Re: PETITION NO. 1345A – North Stonington Solar Center, LLC declaratory ruling, pursuant to Connecticut General Statutes §4-176 and §16-50k, for the proposed construction, maintenance and operation of a 15 MW AC solar photovoltaic electric generating facility on approximately 353 acres comprised of four abutting parcels located east of Pendleton Hill Road, north of the Pawcatuck River and south of Interstate-95 with proposed access from Ella Wheeler Road, and associated electrical interconnection to Eversource Energy's Shunock Substation west of Pendleton Hill Road in North Stonington, Connecticut. Request for 1) an amendment to the declaratory ruling; and 2) approval of a Development and Management Plan –
Response to Interrogatories 1 – 31 (Set 1)

Interrogatories Connecticut Siting Council Set 1
Dated: July 20, 2020

EXHIBIT A

SHEET: **CL-200**

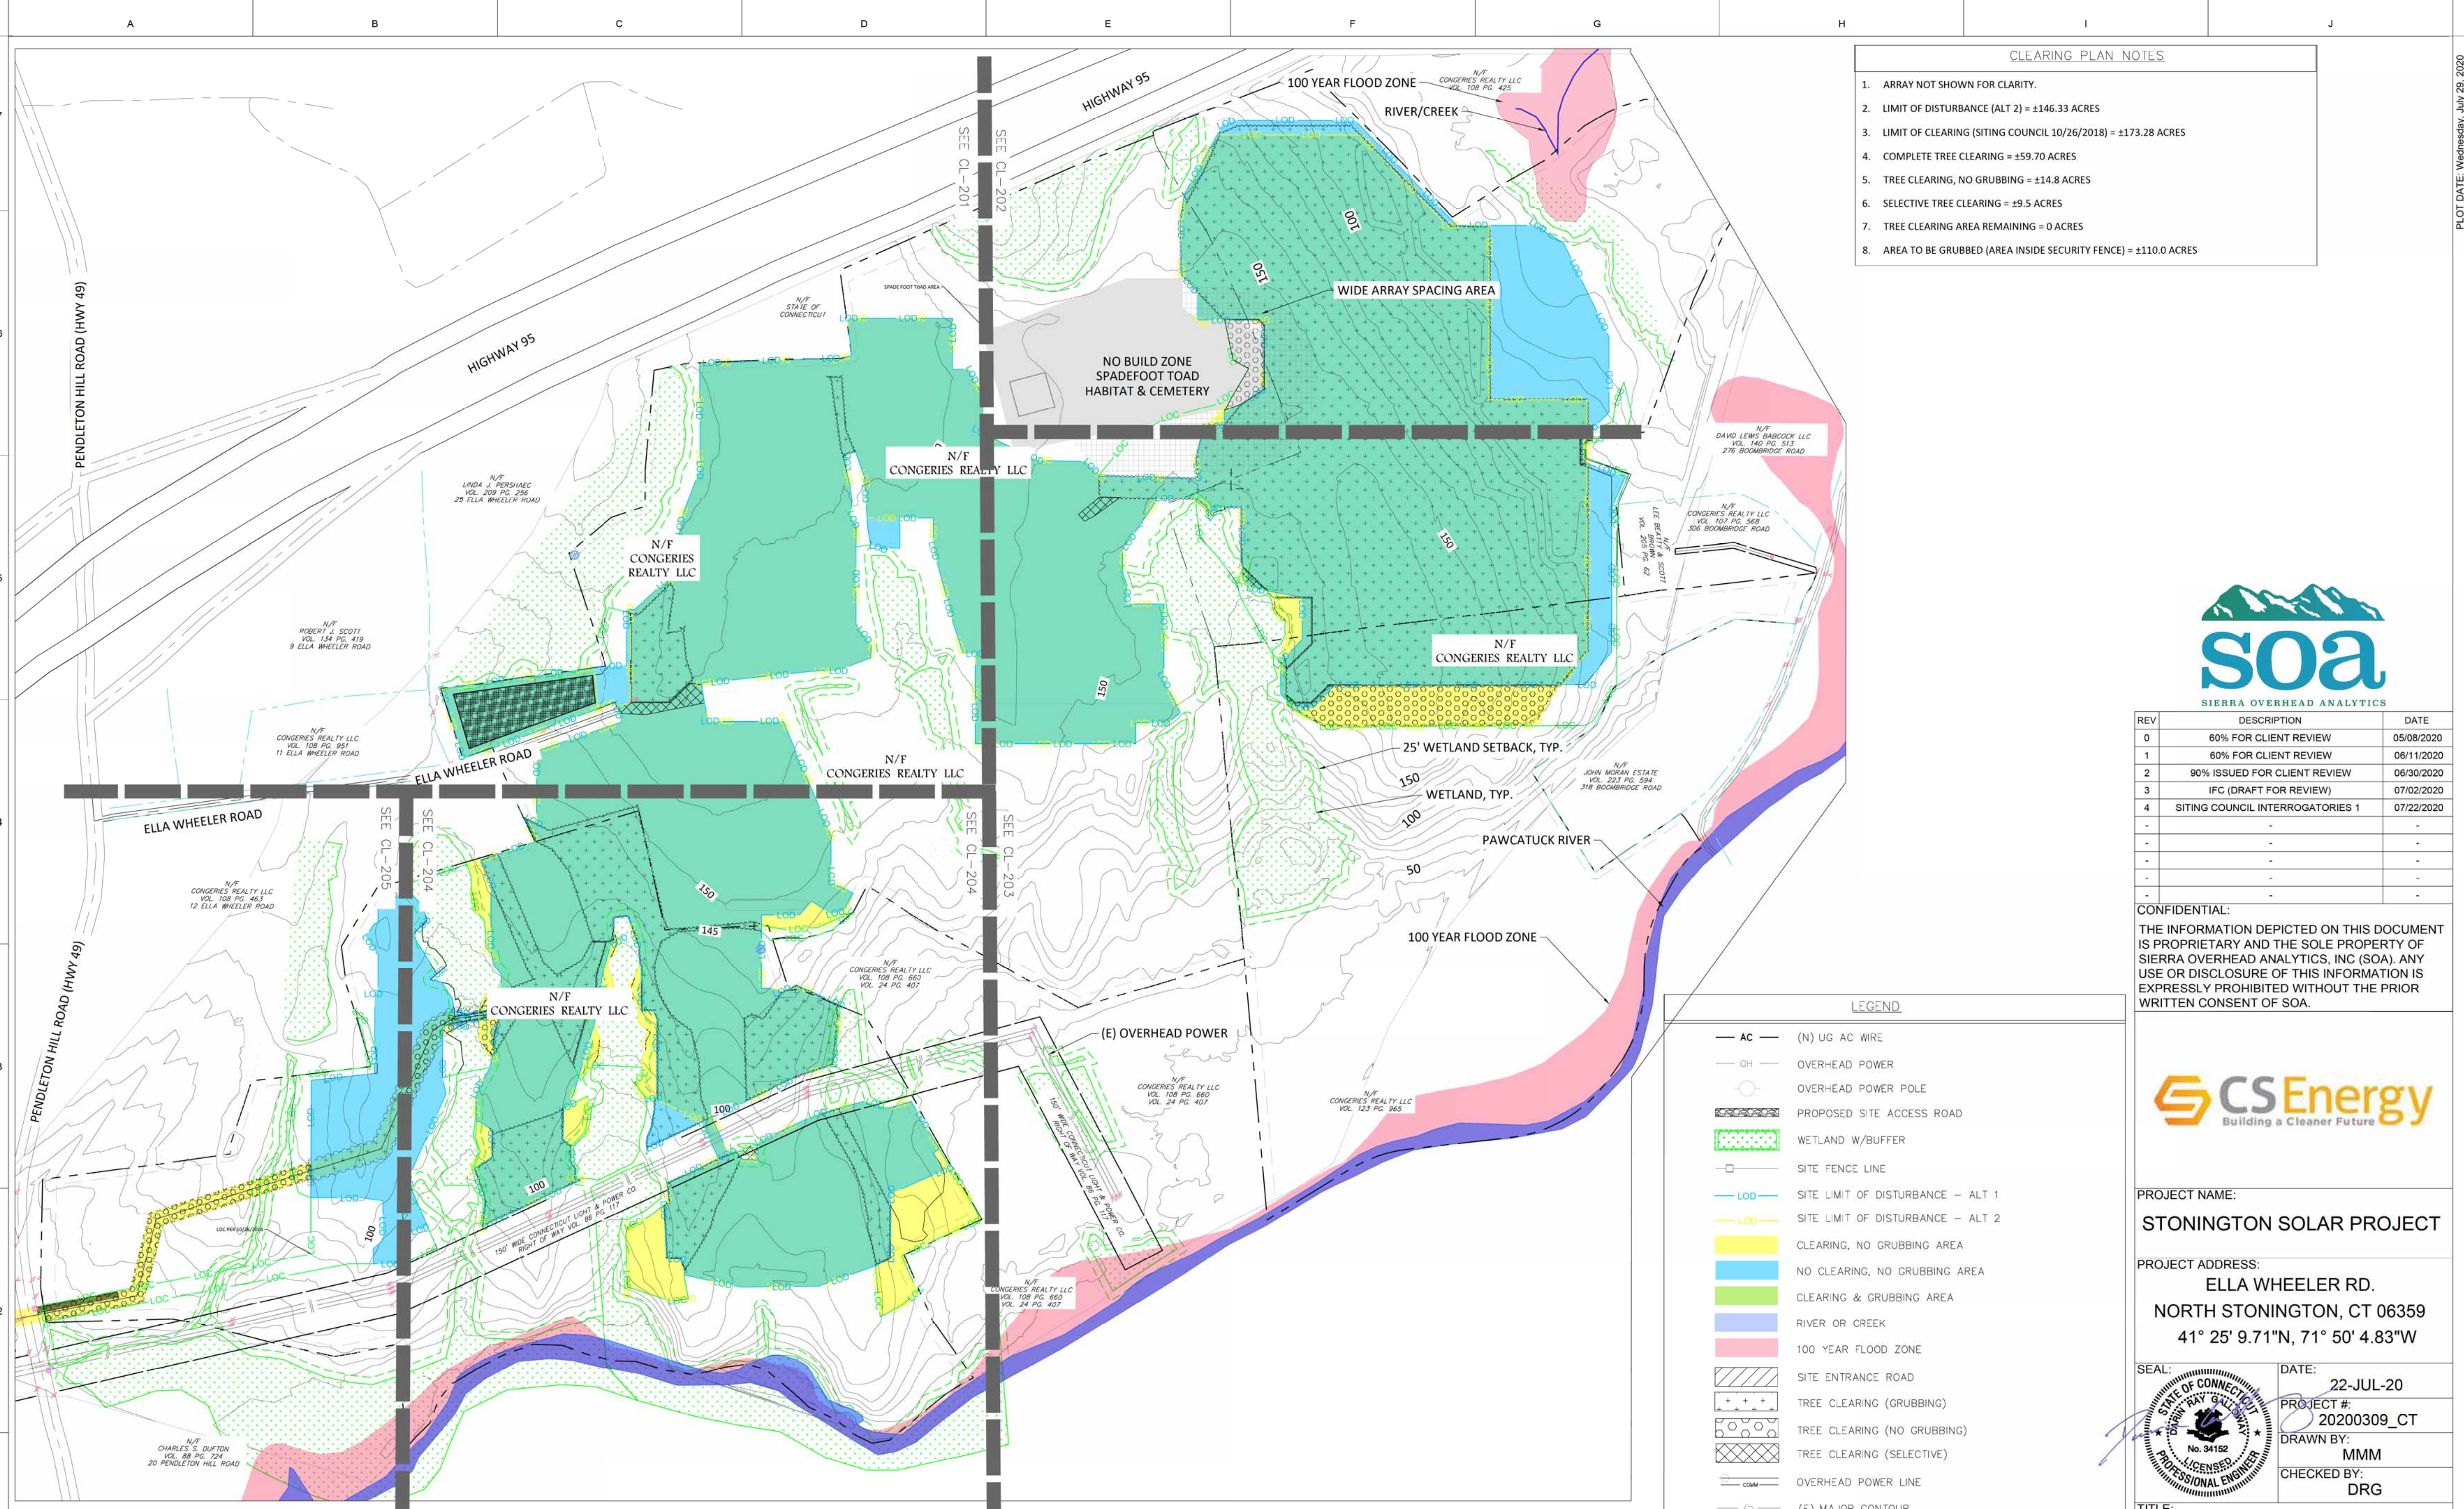
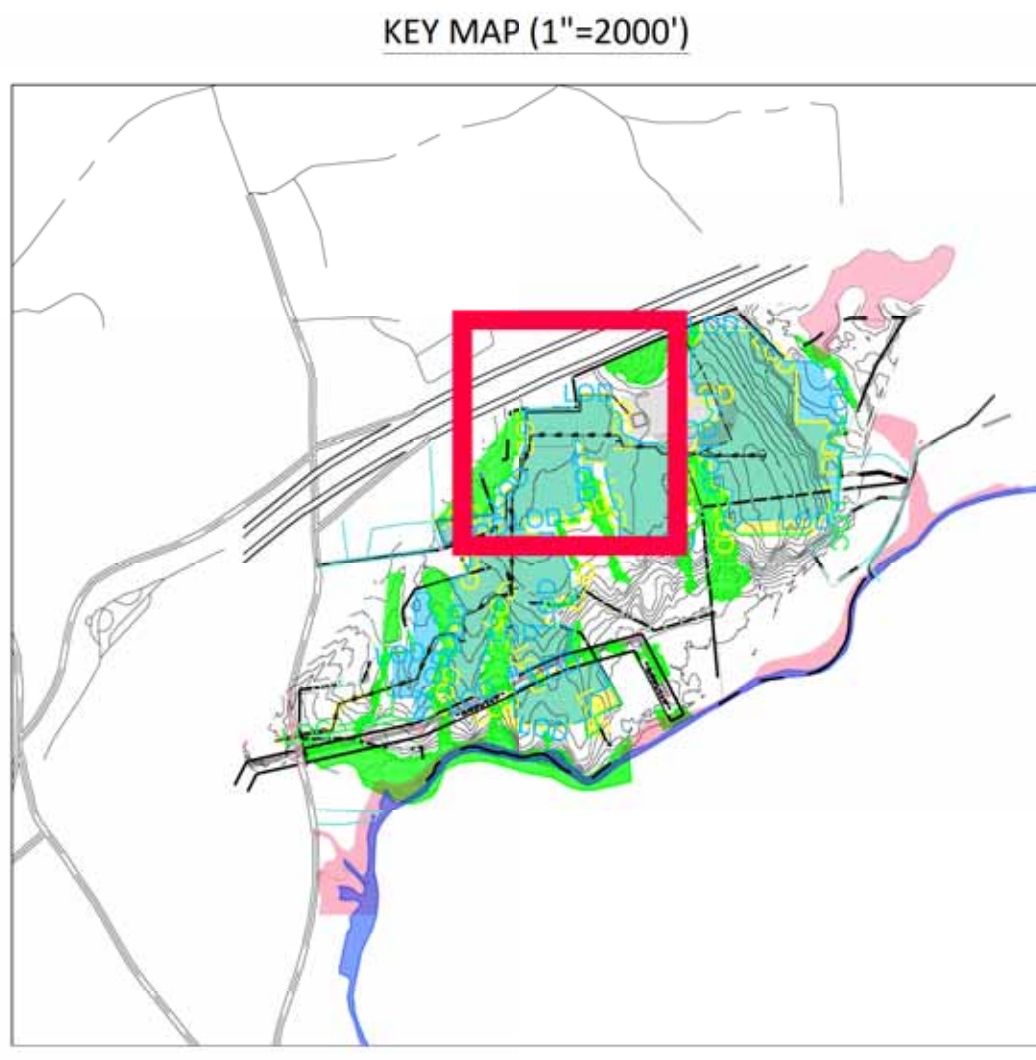
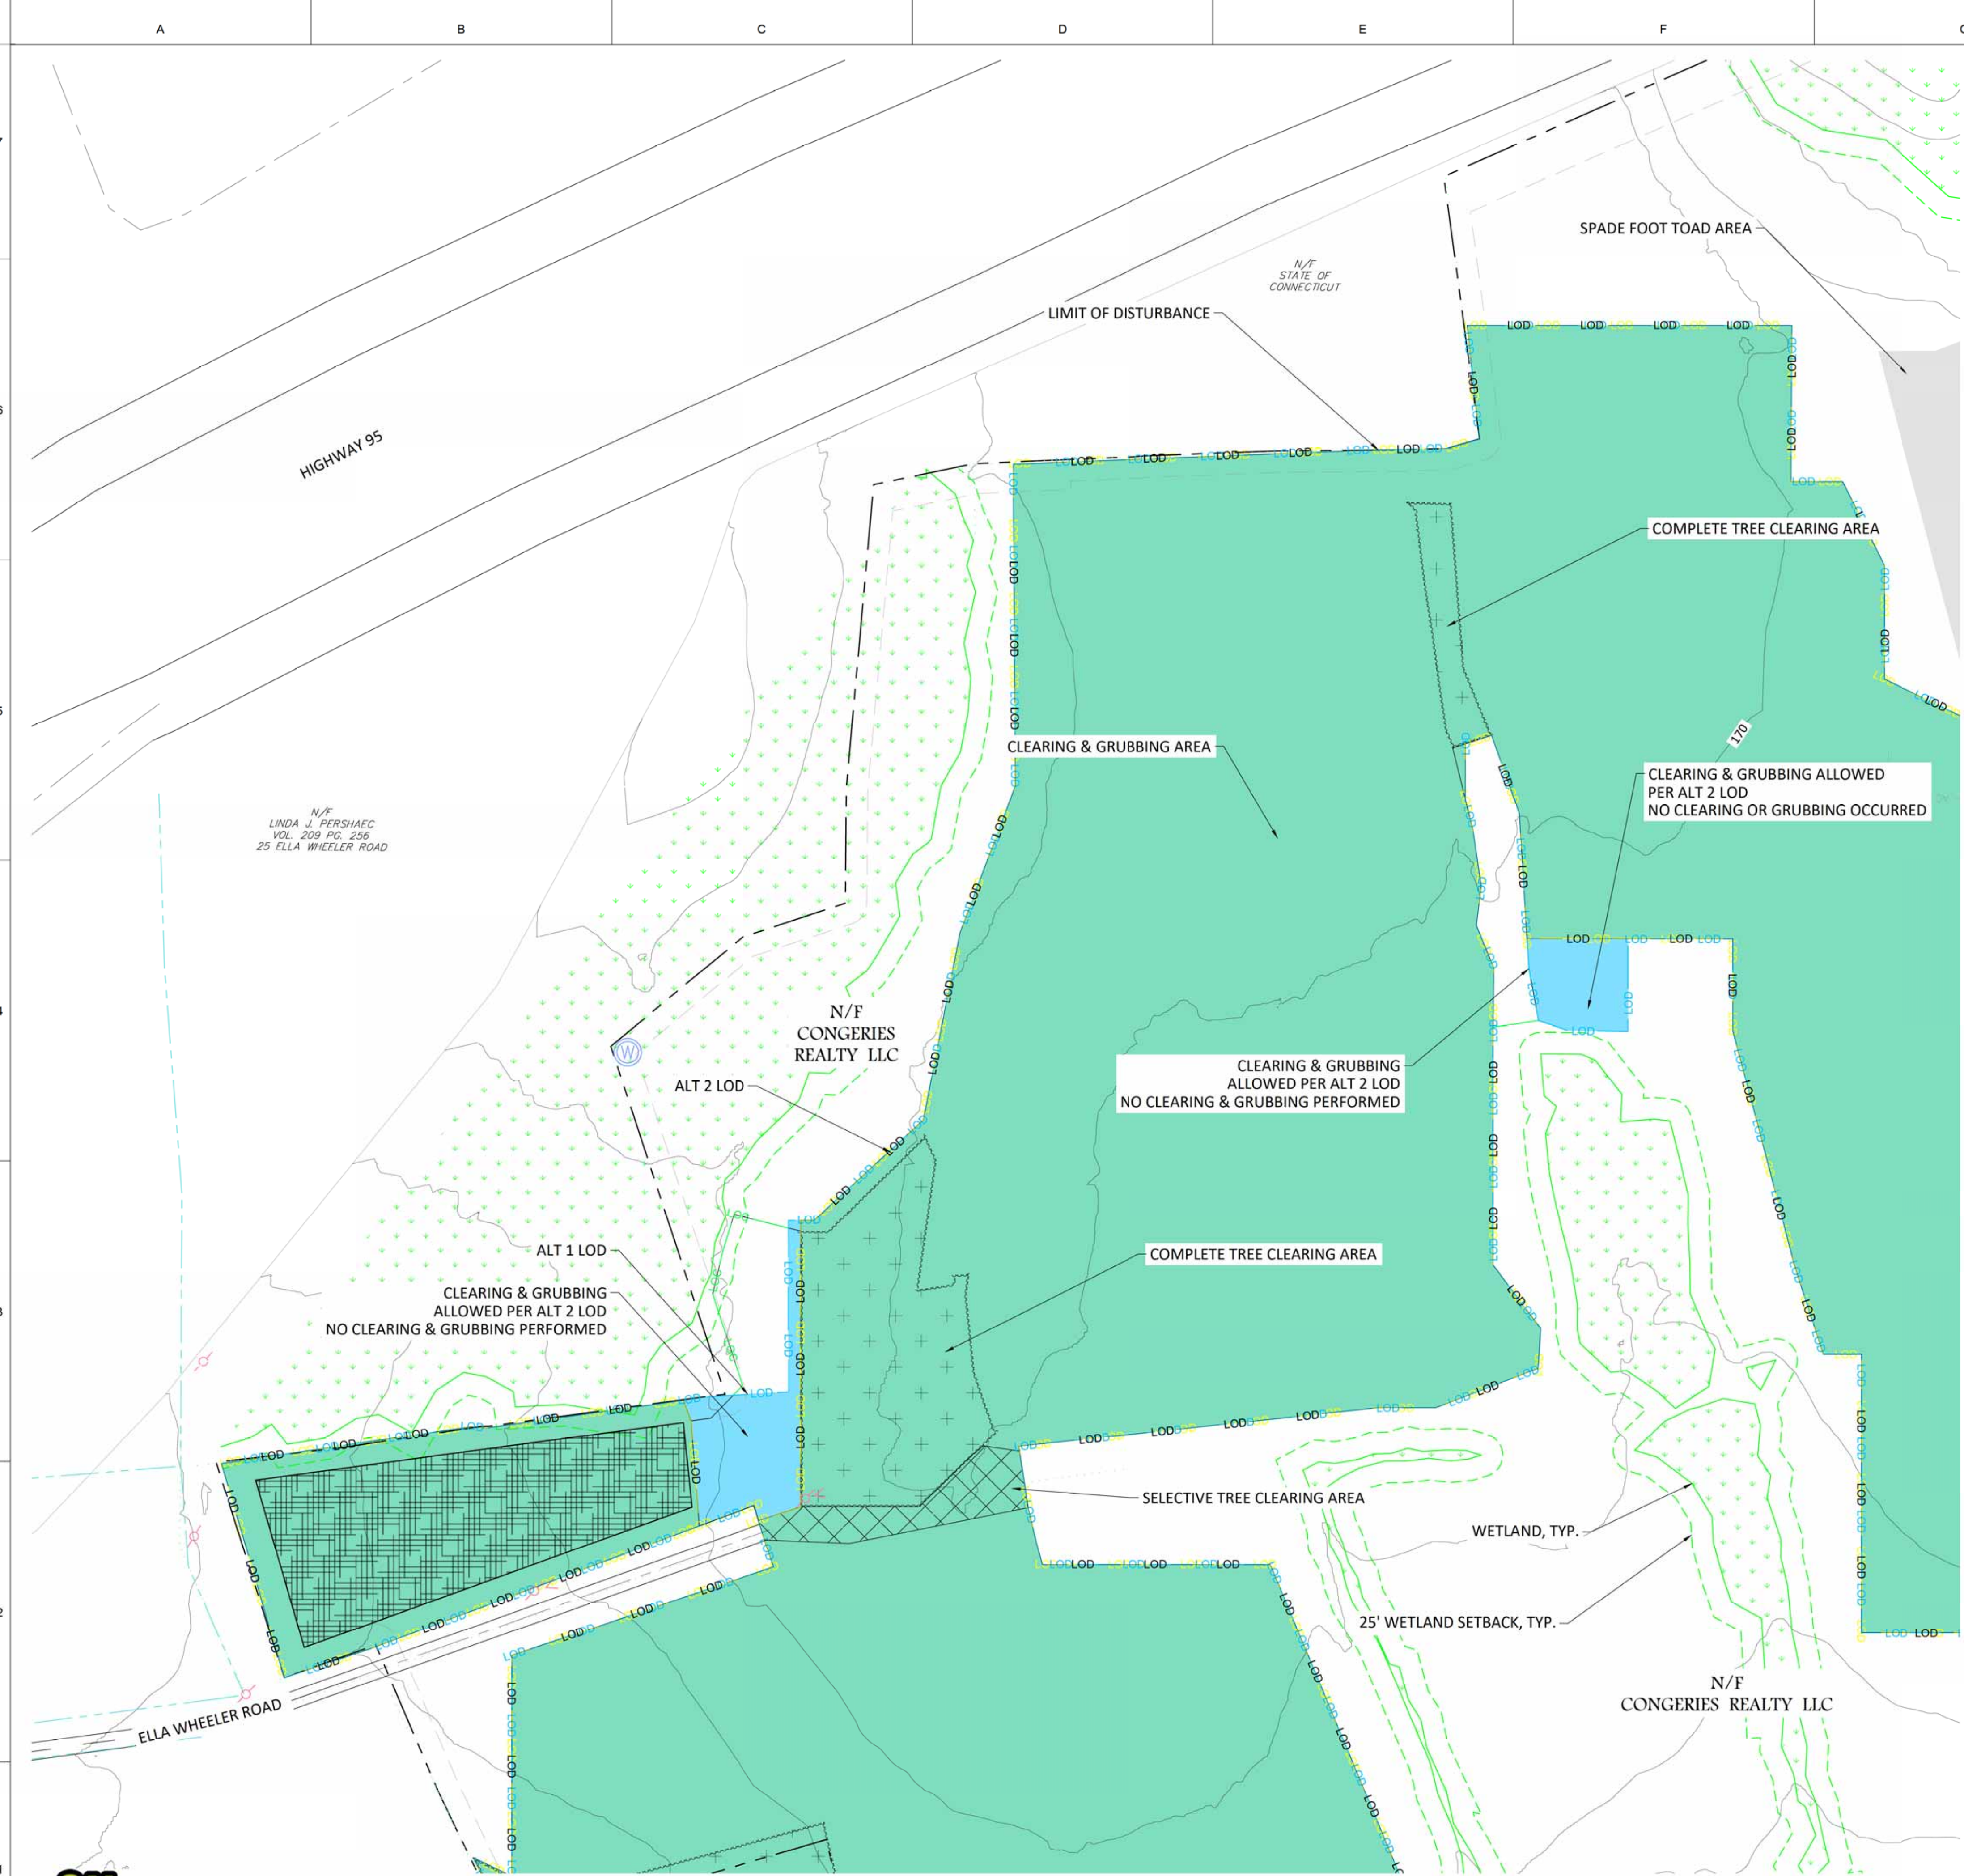
1. Given that the Project has been re-designed several times since the Council's approval on October 26, 2018, and clearing work has been conducted, provide a site plan that clearly shows the following:
 - a) areas that were completely cleared;
 - b) areas that were selectively cleared;
 - c) areas that remain to be cleared;
 - d) areas that require grubbing; and
 - e) clearing boundary of the Council's October 26, 2018 approved site plan.

The project engineering team has compiled a set of drawings which clarify each of the parameters above. Please see Exhibit A attached to these Responses. Please let us know if any items are not immediately clear, we are happy to provide further explanation as needed.

The updated sheet ESC-202 in Exhibit B is provided for your review. In addition, we have added new clearing sheets (CL-200 to CL-205) which highlight the various clearing regions in an easier to view format.
